2.2 Control and Instrument Systems

The information in this section of the reference ABWR DCD, including all subsections, tables, and figures, is incorporated by reference with the following departures.

Figure 2.2.1 Rod Control and Information System Control Interface Diagram

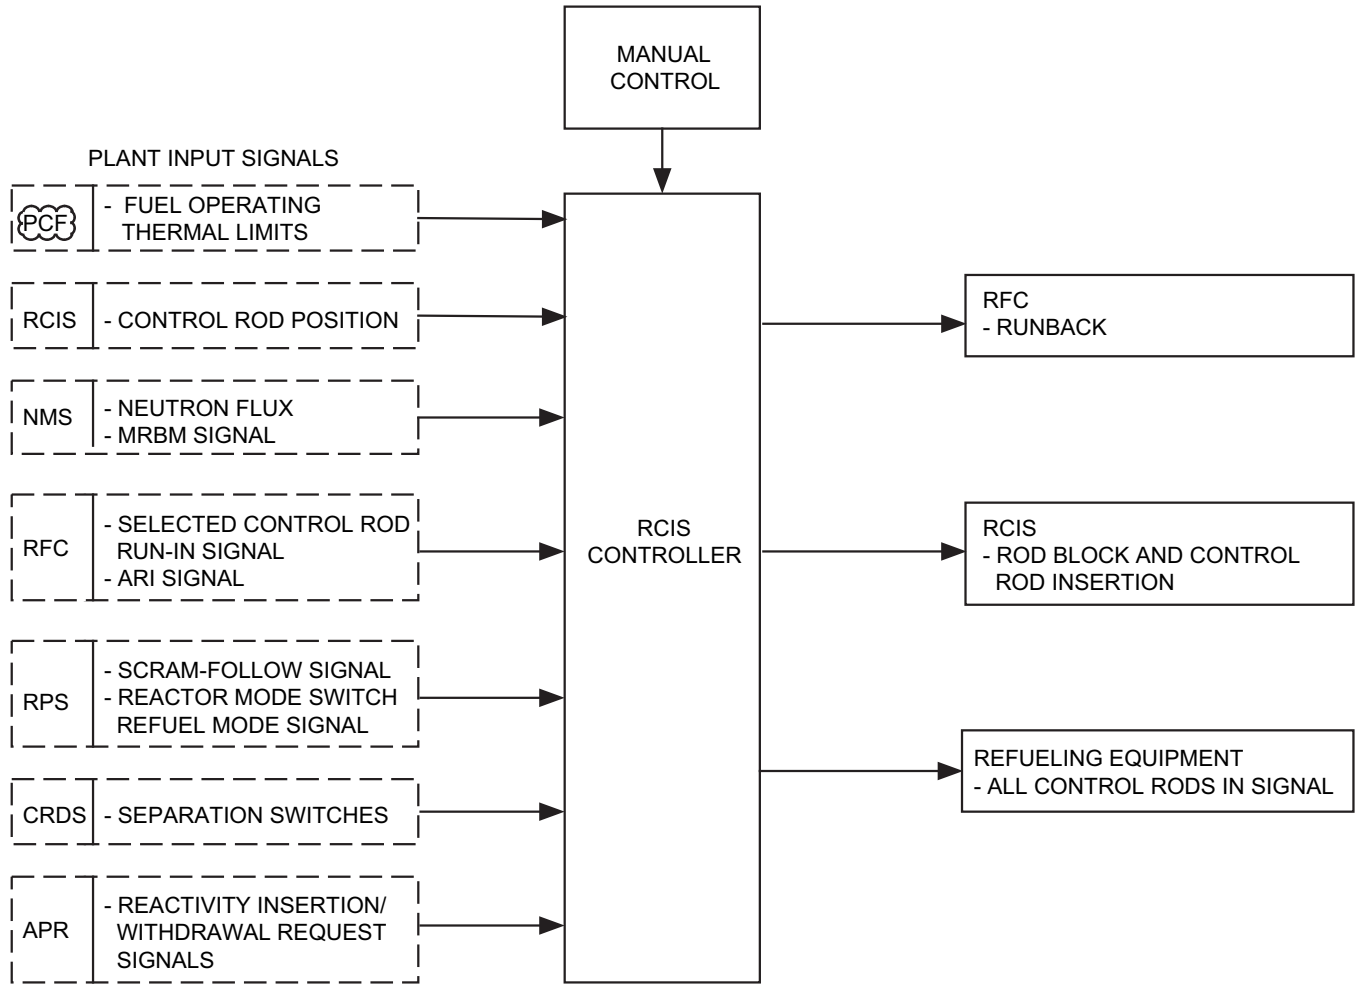
STD DEP T1 3.4-1 (Figure 2.2.1)

NOTE:
1. INTERCONNECTIONS MAY BE FIBER-OPTIC OR METALLIC.

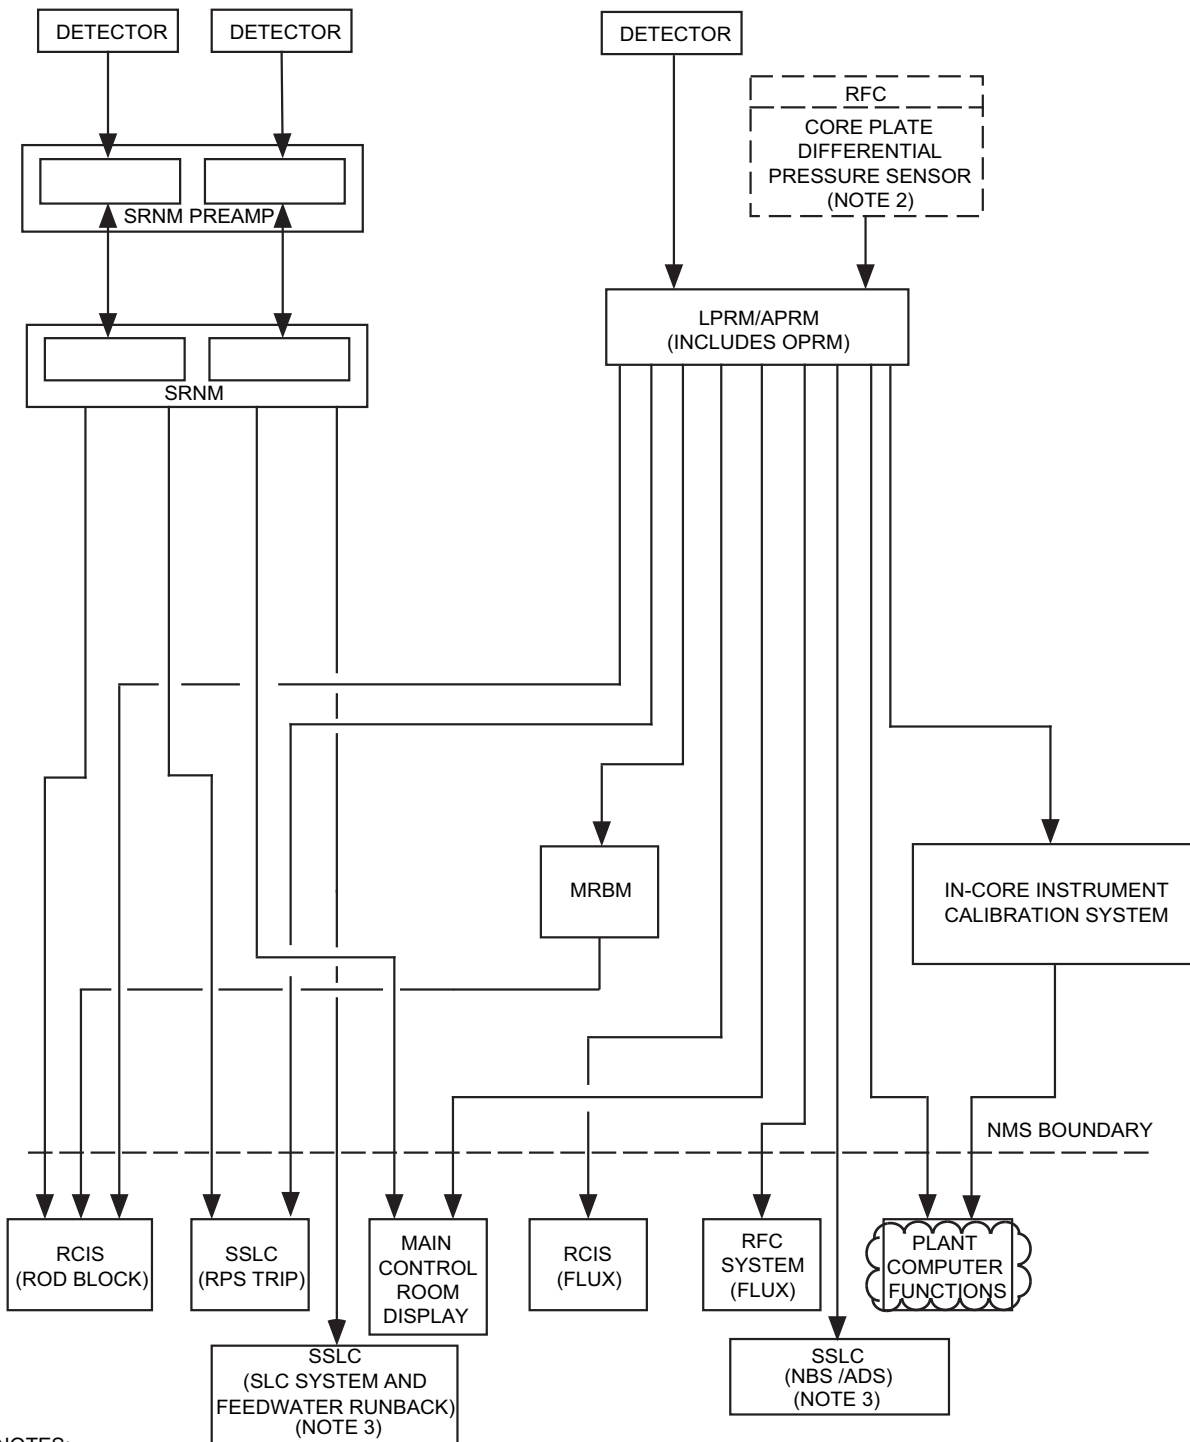
The FDWC digital controllers determine narrow range level signal using three reactor level measurement inputs from the NBS. ~~Sensor signals are transmitted to the FDWC digital controllers by the Non-Essential Multiplexing System (NEMS).~~

The steam flow in each of four main steamlines is sensed at the RPV nozzle venturis. ~~Sensor signals are transmitted to the FDWC System digital controllers by the NEMS.~~ These measurements are processed in the digital controllers to calculate the total steam flow out of the vessel.

Feedwater flow is sensed at a flow element in each of the two feedwater lines. ~~Sensor signals are transmitted to the FDWC digital controllers by the NEMS.~~ These measurements are processed in the digital controllers to calculate the total feedwater flow into the vessel.

Figure 2.2.5 Neutron Monitoring System

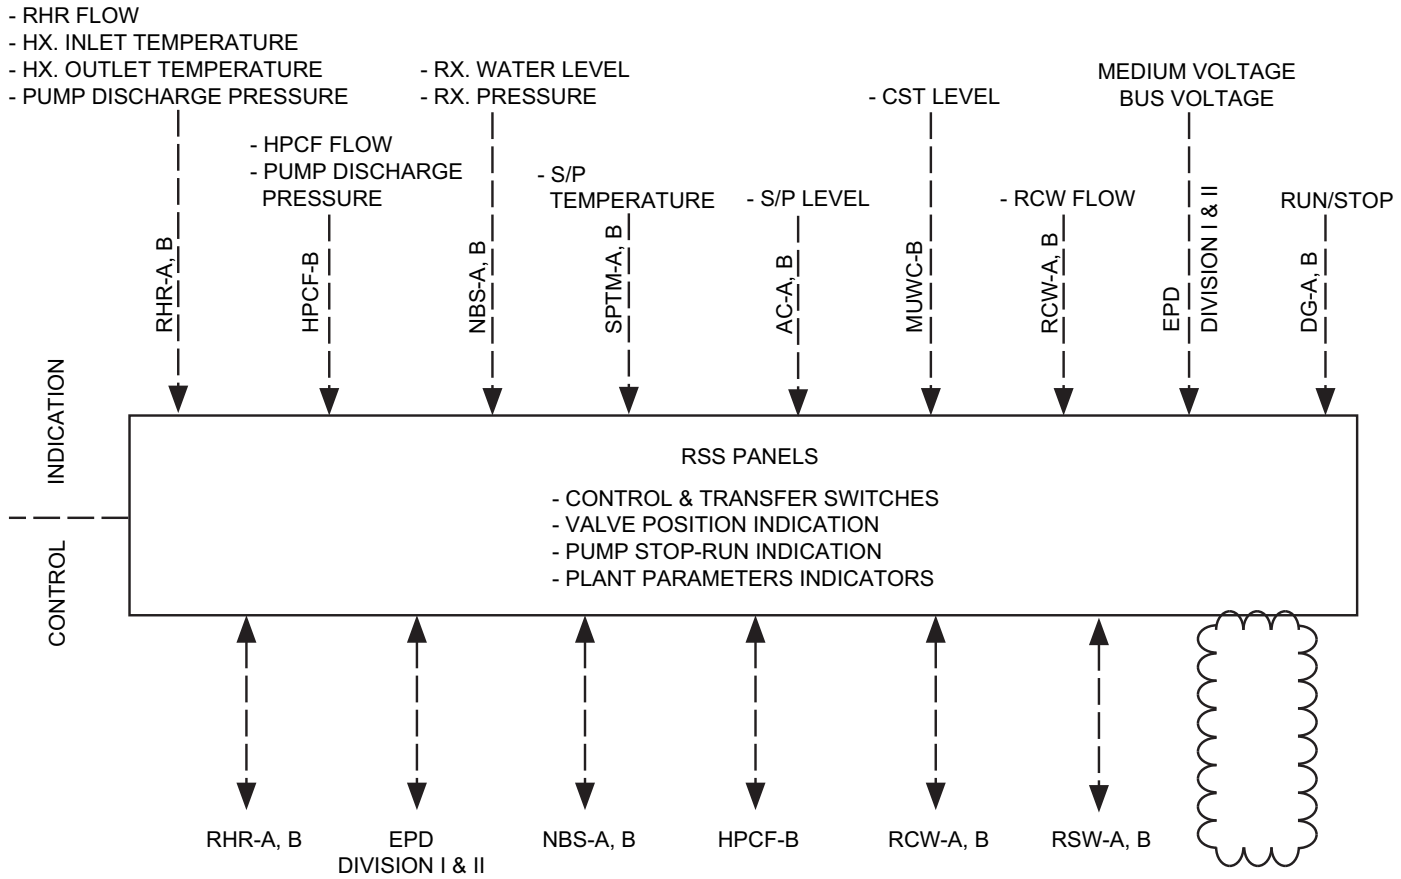
STD DEP T1 3.4-1 (Figure 2.2.5)

The automated in-core instrument calibration system provides local power information at various core locations that correspond to LPRM locations. The automated in-core instrument calibration system uses its own set of in-core detectors for local power measurement and provides local power information for three-dimension core power determination and for the calibration of the LPRMs. The measured data are sent to the ~~Process Computer System~~ Plant Computer Functions for such calculation and LPRM calibration.

Figure 2.2.7b Reactor Protection System

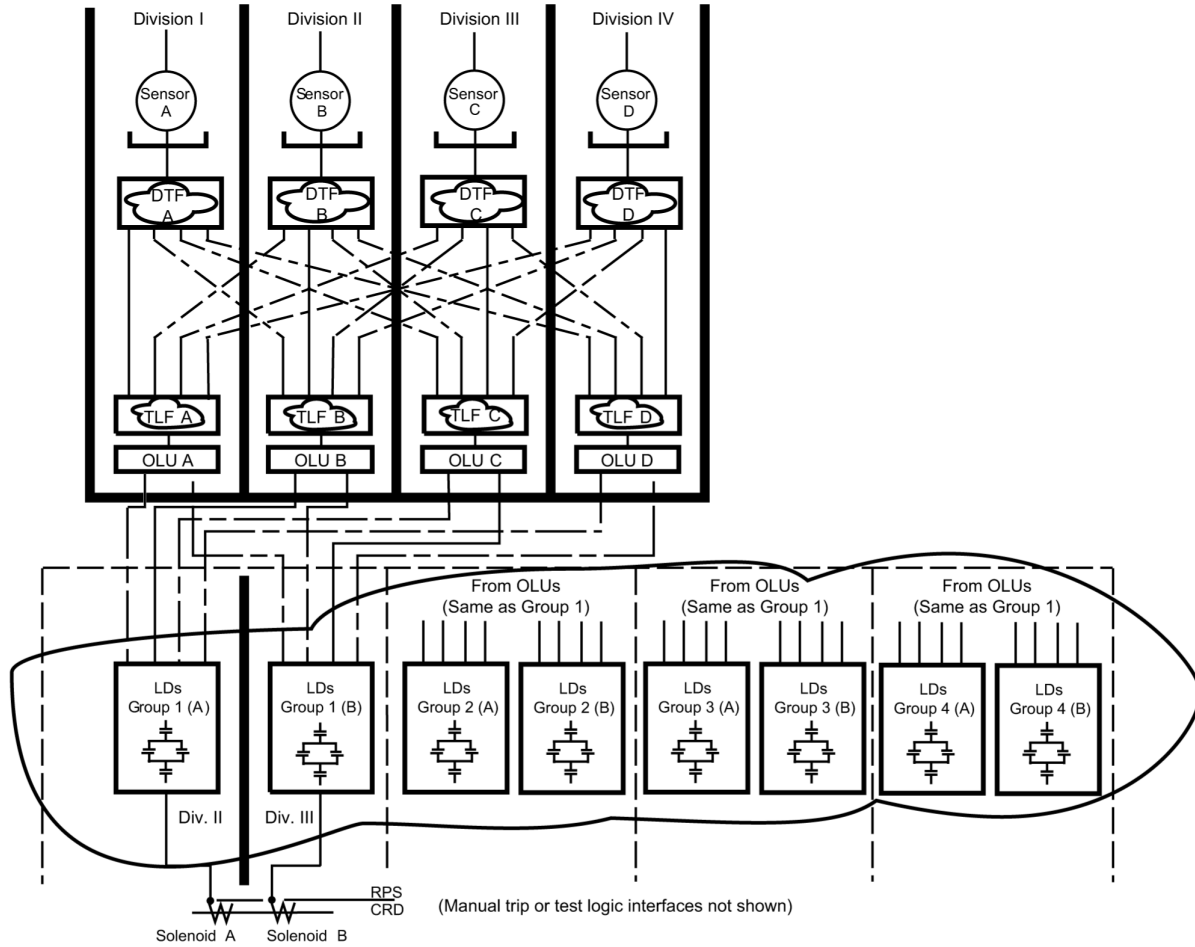
STD DEP T1 3.4-1 (Figure 2.2.7b)

The RPS has four divisions. Figure ~~2.2.6a~~ 2.2.7b shows the RPS divisional aspects and the signal flow paths from sensors to scram pilot valve solenoids. Functions Equipment within an RPS division consists of include sensors (transducers or switches), I/O, ~~multiplexers~~, data communication, digital trip modules functions (DTM DTF), trip logic unit function (TLU TLF), output logic unit (OLU), and load drivers (LD). The LDs are only in Divisions II and III. The (DTF) and (TLF) are performed in digital configurable logic devices. The data communication functions are described in Section 2.7.5.

The RPS consists of logic and circuitry for initiation of both automatic and manual scrams. The automatic scram function is ~~comprised of~~ accomplished redundantly in four independent divisions of sensor instrument channels, hardware/software based logic and logic processing, and two independent divisions of actuating devices. Automatic scram is initiated whenever a scram condition is detected by two or more automatic divisions of RPS logic. ~~For automatic scram, the sensor input signals to the RPS originate either from the RPS's own sensors or other systems' sensors. For determination of the existence of an automatic scram condition, within each automatic scram channel division of the RPS, the DTM DTF of a given RPS channel division compares the monitored process variable with the a stored setpoint stored in its memory and issues a trip signal if the monitored process variable exceeds the setpoint. The DTM DTF then sends the trip signal to the TLU TLF of its own channel division and the TLU TLFs of the other three channels divisions of RPS, where two-out-of-four voting is performed (see Figure 2.2.6a). The TLF in each division performs an independent two-out-of-four vote on each RPS DTF input.~~

The ~~TLU~~ TLFs provide their trip signals to their divisional OLUs which ~~are used to~~ control the solid-state LDs that control the Class 1E AC power to the scram solenoids, and relays that control DC power to back-up scram valves. For automatic scram initiation, the ~~TLU~~ TLF trip signals cause the LDs to interrupt Class 1E AC power to the scram solenoids (fail-safe logic), cause the back-up scram relays to supply DC power to back-up scram solenoids, and provide scram follow signals to the RCIS. Each division of RPS controls eight LDs. The LDs are arranged to switch AC power to the scram solenoids in a two-out-of-four ~~format arrangement~~. That is, reactor scram will occur only if two or more divisions of the RPS provide trip signals to their associated LDs and both scram solenoids are de-energized.
